BrewDog, Manchester, M2 5BG, Pedestrian visibility requirements

EAS Transport Planning Ltd has been appointed by Firstplan to provide highways advice in response to Manchester Highways Authority comments with regards to the pedestrian visibility at the site of, BrewDog Manchester, Peter Street, M2 5BG. A site location plan is contained at **Appendix A**.

Figure 3 Crashmap extract (2012 - 2021)

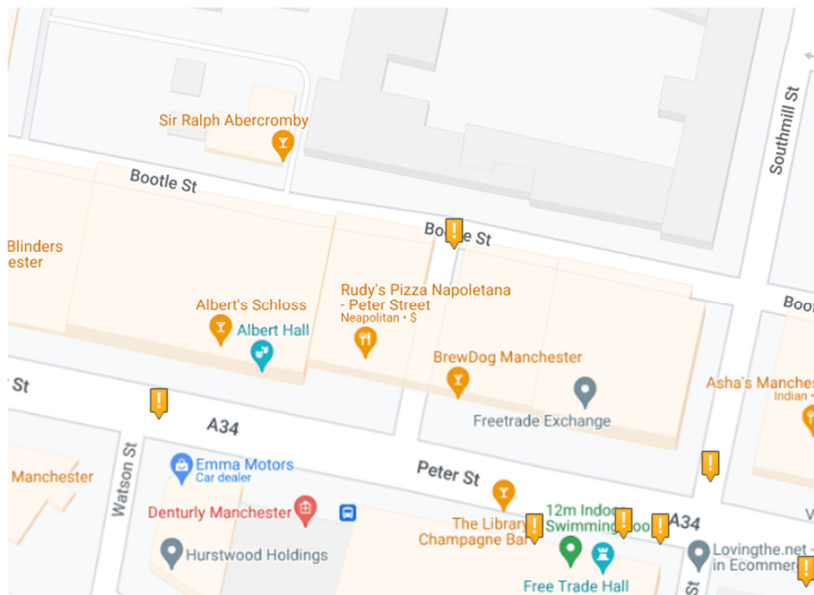
The Crashmap database was analysed from 2021 – 2012 to review any injury accidents at the junction, particularly ones involving pedestrians. Figure 3 highlights the map of accidents between the years of 2012 and 2021 in the local area.

In the 10 year period, in which the 900mm wall was present outside BrewDog, there were no recorded accidents involving pedestrians or any vehicles at the junction with Maldon Place and Peter Street. It can be concluded that vehicle/pedestrian inter-visibility has not been an issue in this area.

Appendix B – Proposed Site Plan with Pedestrian Visibility:

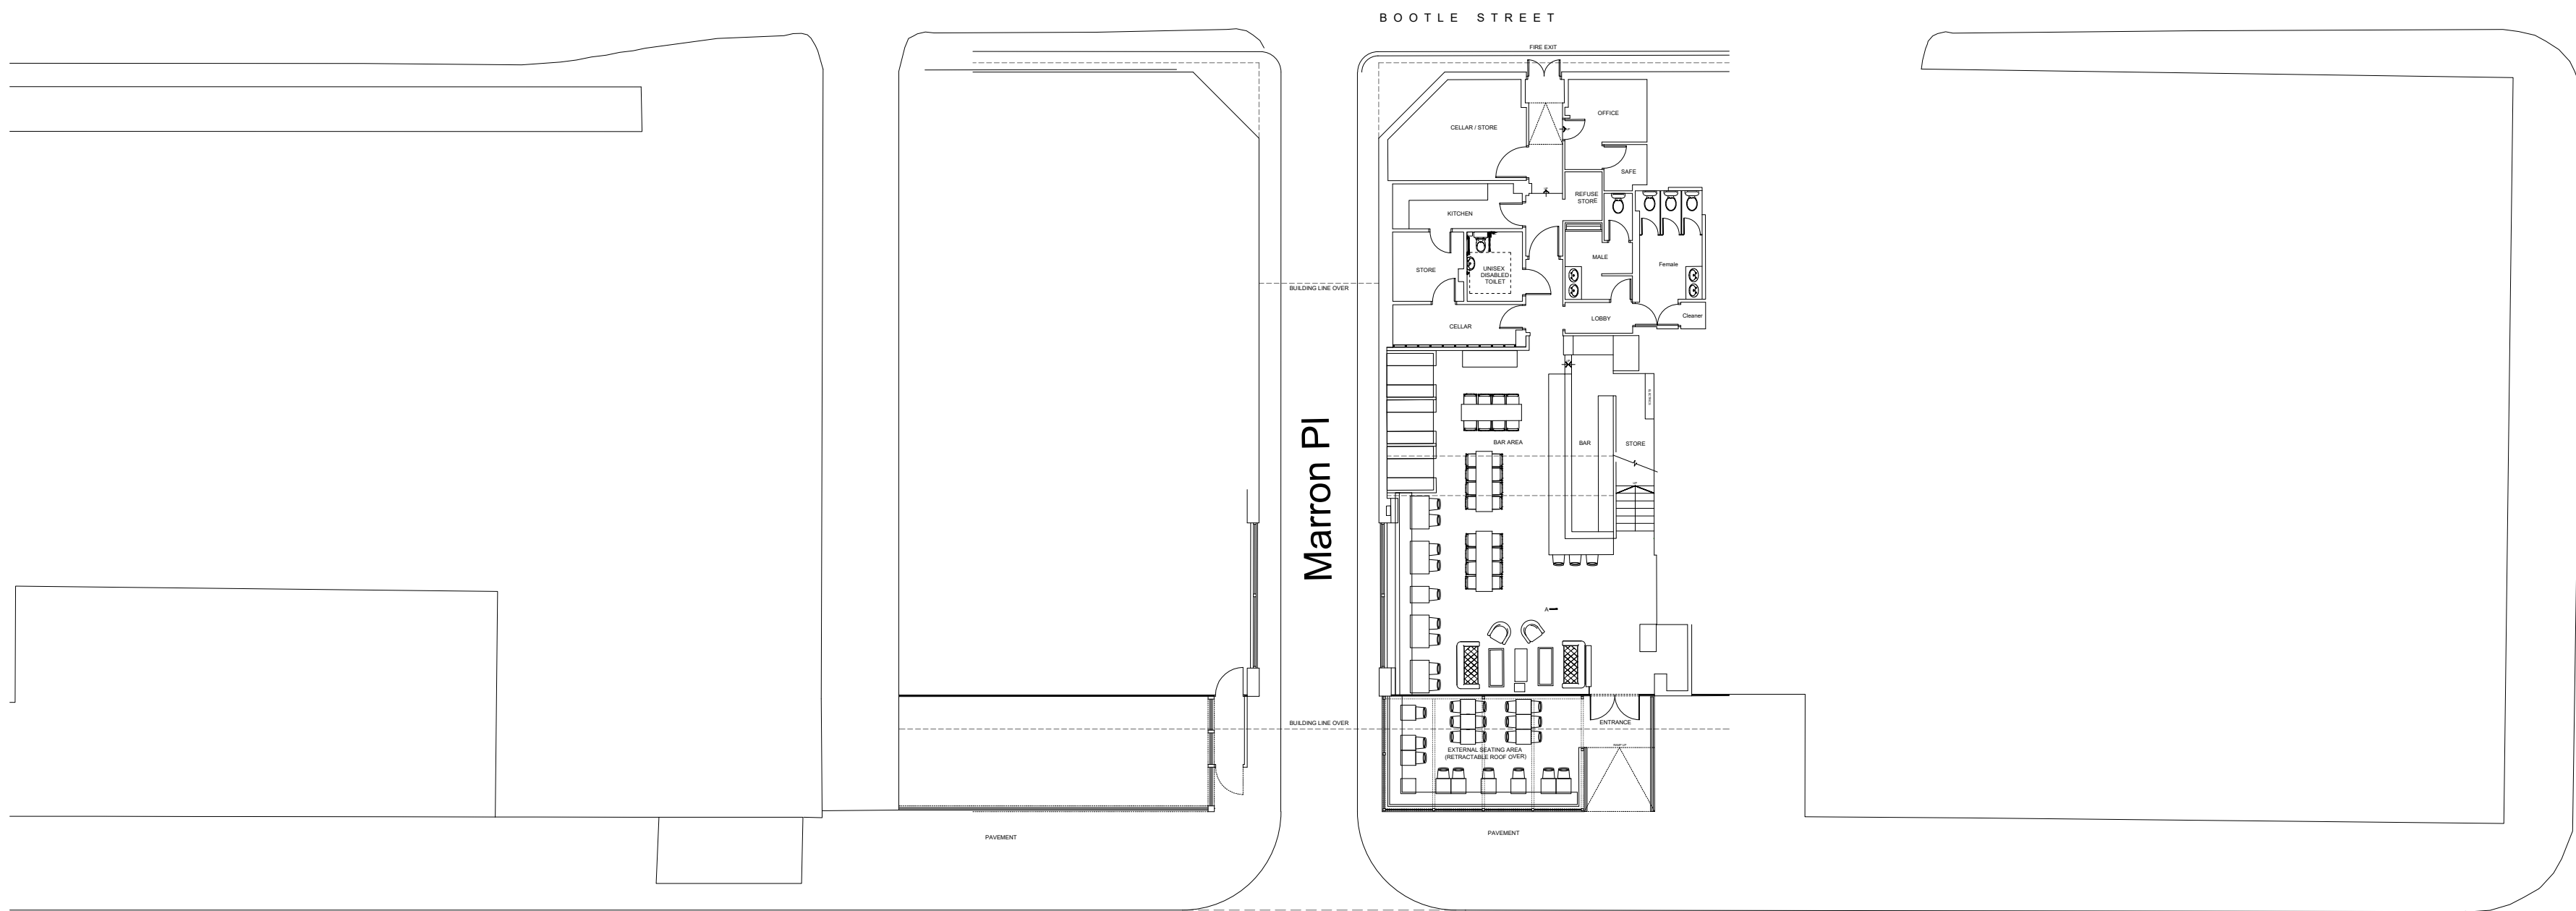
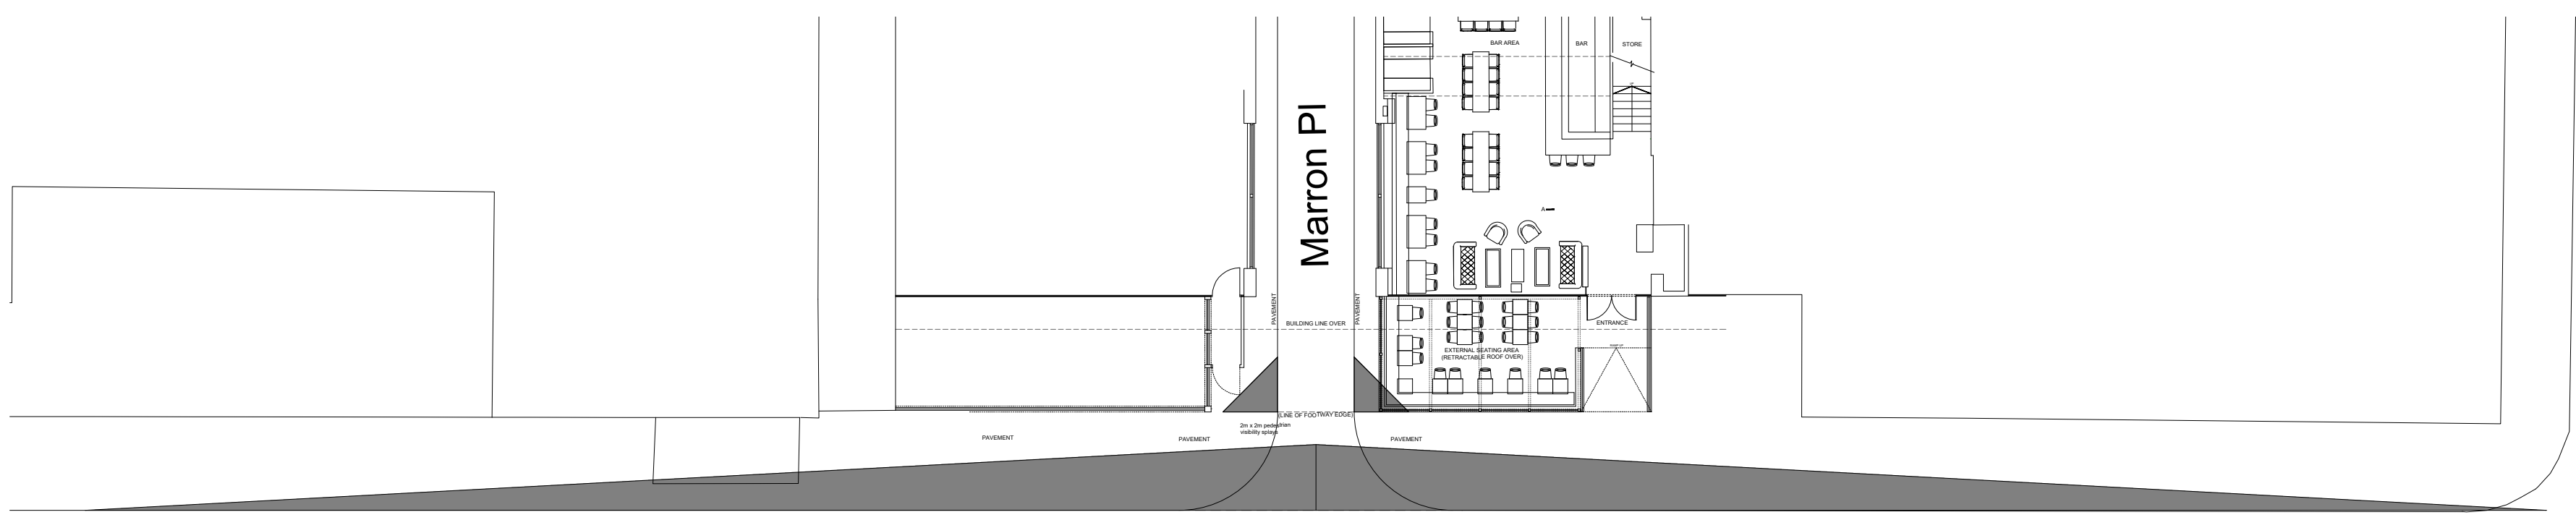
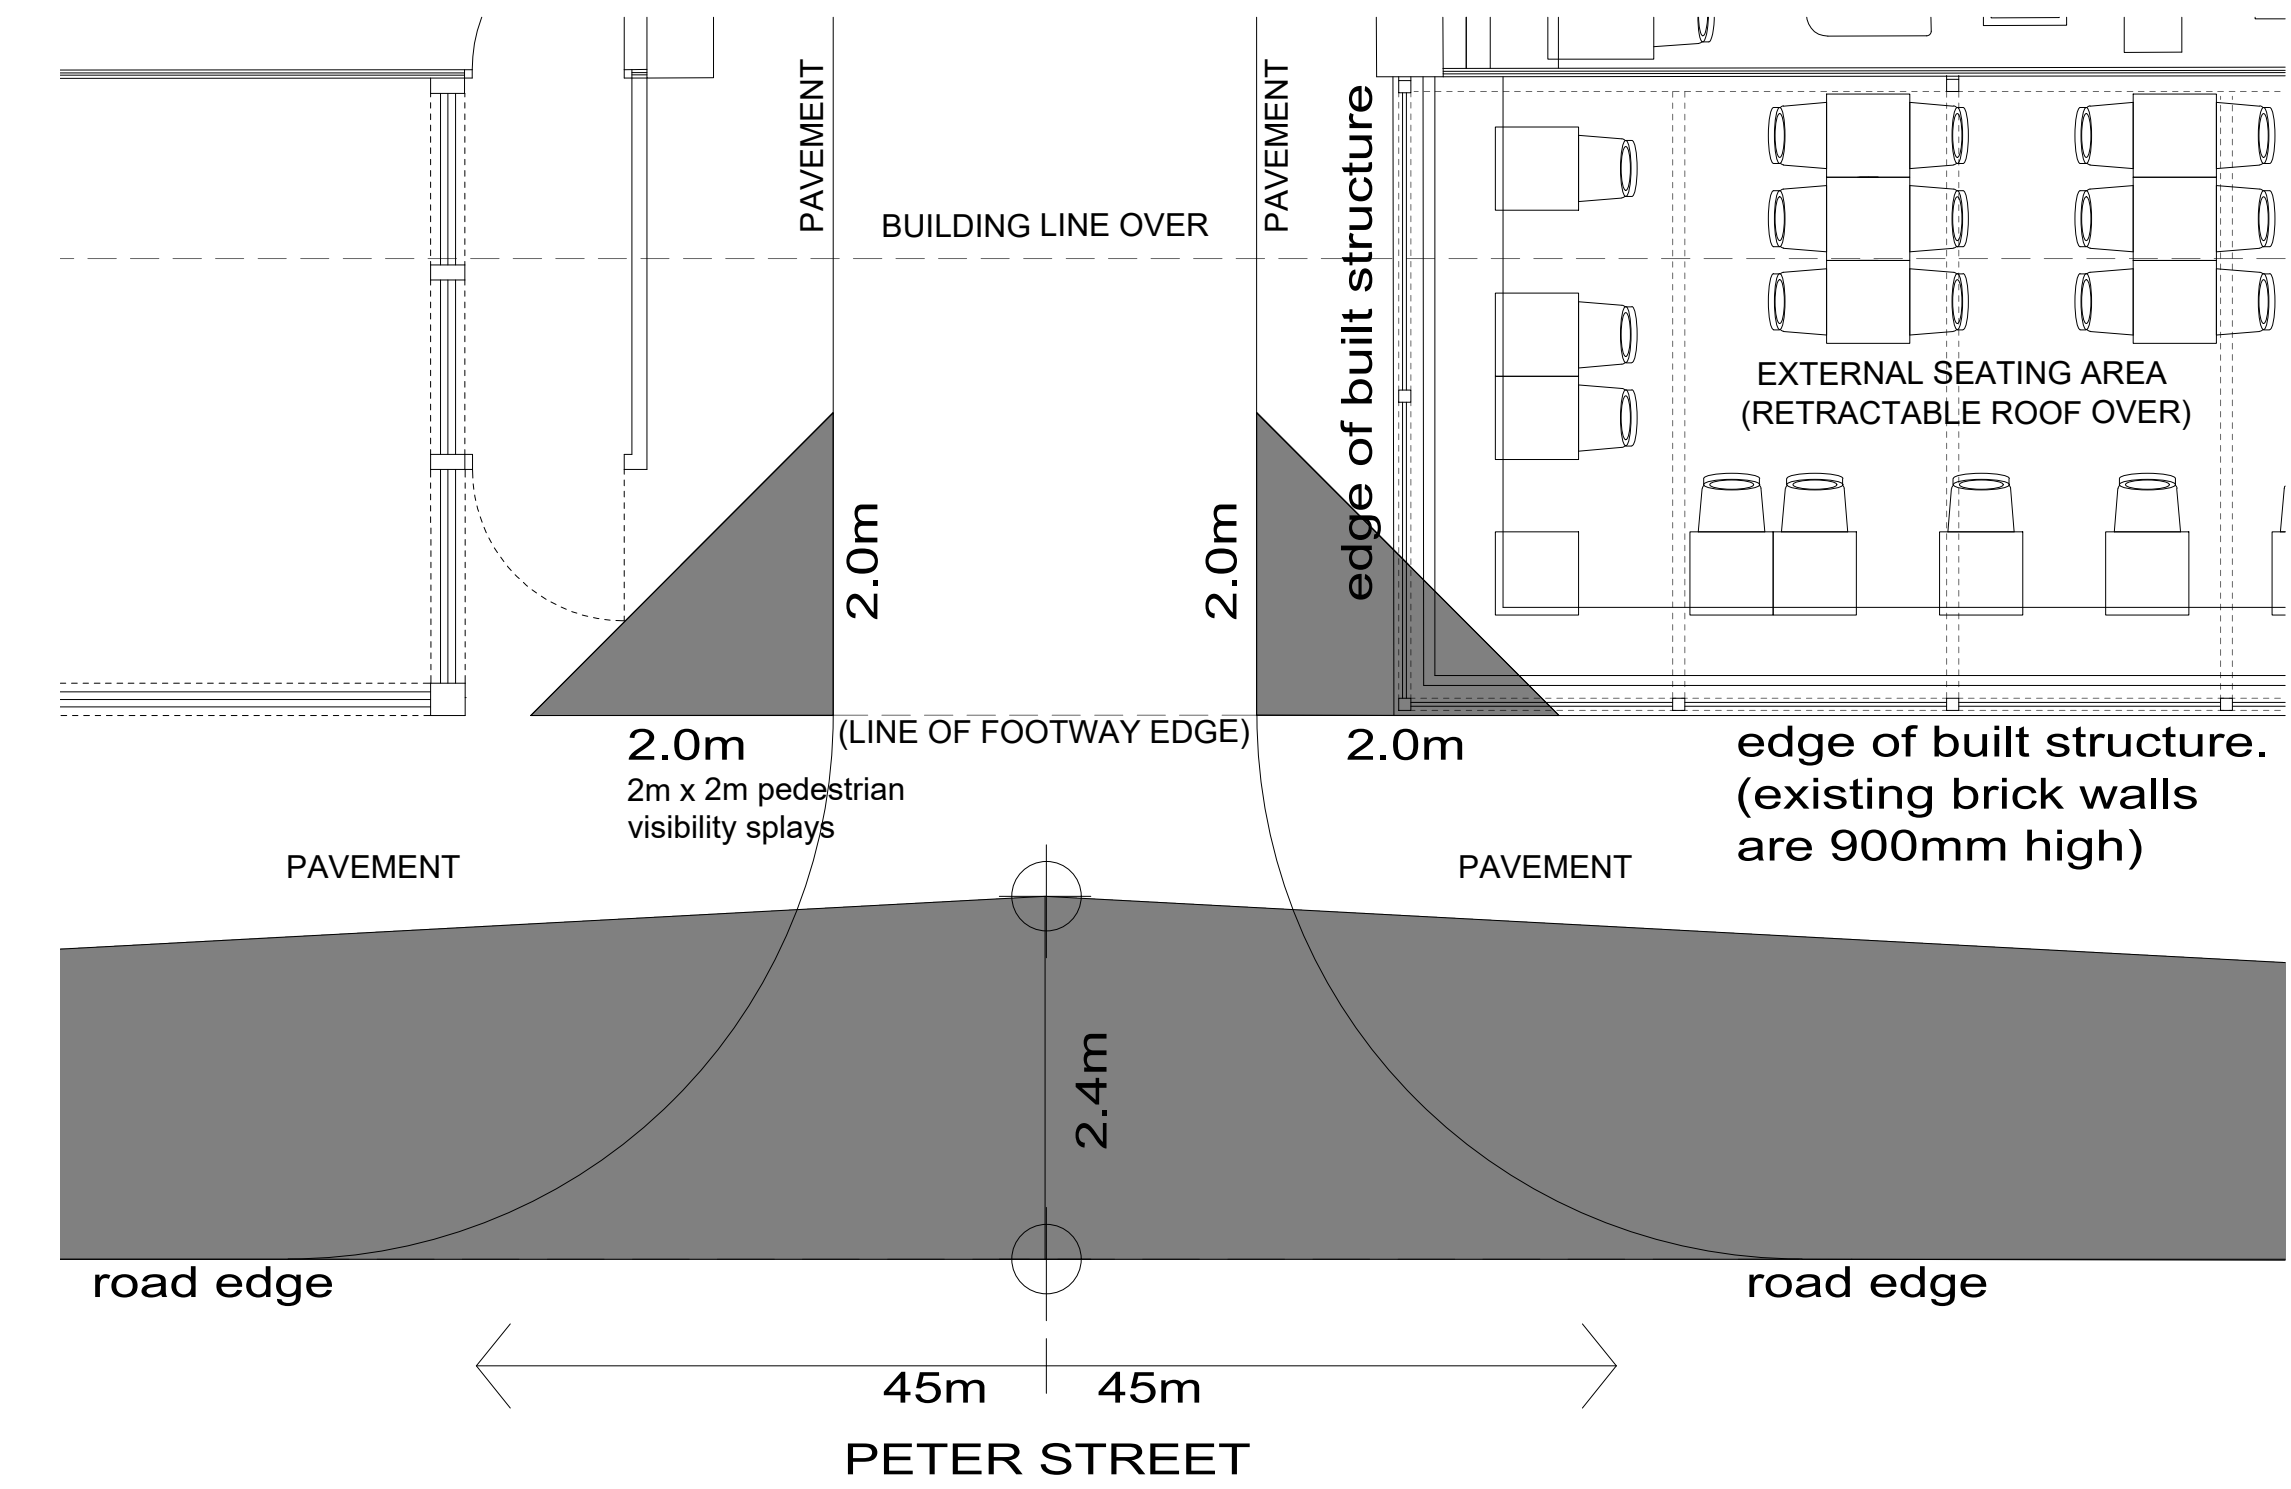
“my concern is driver view of crossing pedestrians when emerging from Marron Place, this is why I requested a 2m x 2m pedestrian visibility splay – but this has not been depicted on the plan provided. The plan should also show the retained footway width to makes sure enough clearance is provided so emerging vehicles don’t hit the structure when emerging/turning.”

No direct information could be found in the Manchester design guide regarding pedestrian visibility however, following the Highway officers' comments it is assumed that the standards are 2m x 2m splays of which all have to be clear of obstacles over 600mm. Whilst the drawing contained at **Appendix B**

highlights the visibility cutting through the edge of the existing wall, with footway widths of circa 3.2m outside the site pedestrians crossing are unlikely be hugging the wall of the site. If measuring the visibility 1m offset from the wall, then 2m visibility is achievable whilst still allowing 2.2m of footway between them and Peter Street carriageway.
